**Technical Service
BULLETIN**

**ACCESSORY DRIVE BELT/
BELT TENSIONER ASSEMBLY NOISE**

'03 – '07 Corolla & Matrix

**ENGINE
EG021-07**

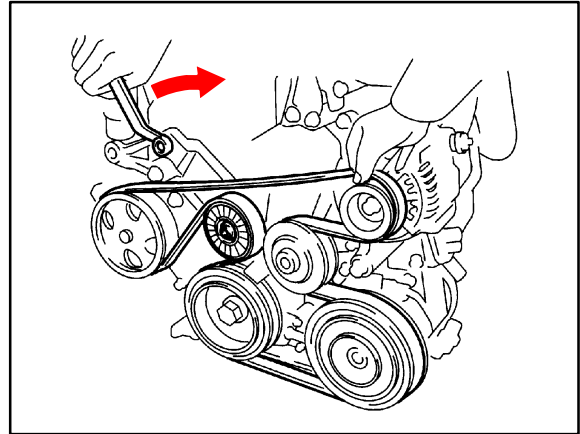
Introduction Some 1ZZ-FE and 2ZZ-GE engines may exhibit a squealing and/or rattling noise coming from the engine compartment during vehicle operation. The belt tensioner assembly has been improved to correct this condition.

ENGINE	PREVIOUS PART NUMBER	CURRENT PART NUMBER	PART NAME	QTY
1ZZ-FE	16620-22012	16620-22013	Tensioner Assembly, V-belt	1
2ZZ-GE	16620-22032	16620-22033		1
1ZZ-FE	90080-91139-83	Same	Belt, V	1
2ZZ-GE	90916-A2007	Same		1

1. Verify that the noise is coming from the accessory drive belt/belt tensioner assembly.
2. Inspect the accessory drive belt and belt tensioner assembly.
If there is any roughness to either of the belt tensioner assembly bearings or any sign of damage, scoring, or glazing on the accessory drive belt, replace BOTH the belt tensioner assembly and the accessory drive belt.
3. Remove the drive belt.
